NEDO-33911-A, Revision 2

BWRX-300 Containment Performance

UNITED STATES
NUCLEAR REGULATORY COMMISSION
WASHINGTON, D.C. 20555-0001

SUBJECT: FINAL SAFETY EVALUATION FOR GE-HITACHI LICENSING TOPICAL
REPORT NEDC-33911P, REVISION 0, SUPPLEMENT 1, "BWRX-300
CONTAINMENT PERFORMANCE"

Figure 2-8: FMCRD CIVs Connected to RPV Boundary

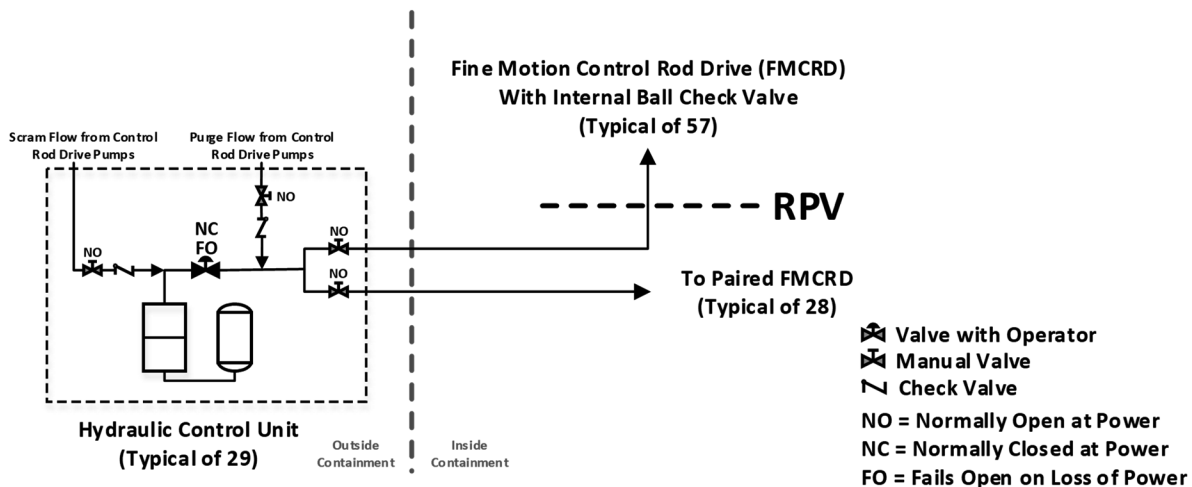
NEDC-33911, Section 2.2.7.1 states that the containment penetrations for fine motion control rod drive (FMCRD) hydraulic lines (shown on Figure 2-8 of NEDC-33911) do not have isolation valves based on closed-system piping outside the primary containment vessel (PCV) and reactor coolant pressure vessel (RCPB) isolation valves (internal ball check valves) in the design of the drives.

Figure 2-9: CIVs Connected to Containment Atmosphere

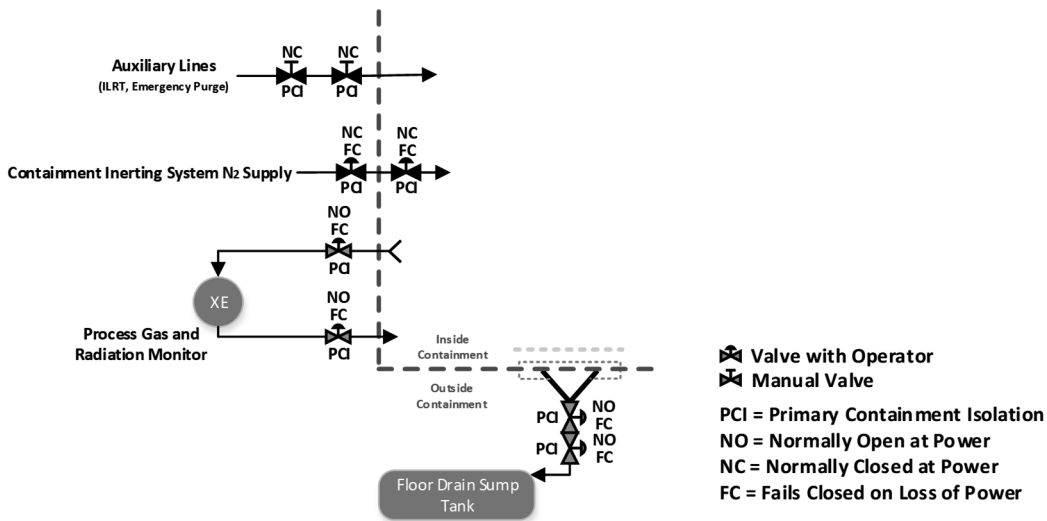
The NRC staff finds that the approach described in NEDC-33911P, Section 5.1.23, Section 2.2.7.2, and Figure 2-9 to be consistent with GDC 56 and, therefore, is acceptable. The NRC staff will conduct a detailed evaluation to confirm that GDC 56 is satisfied when it receives an application for a BWRX-300.
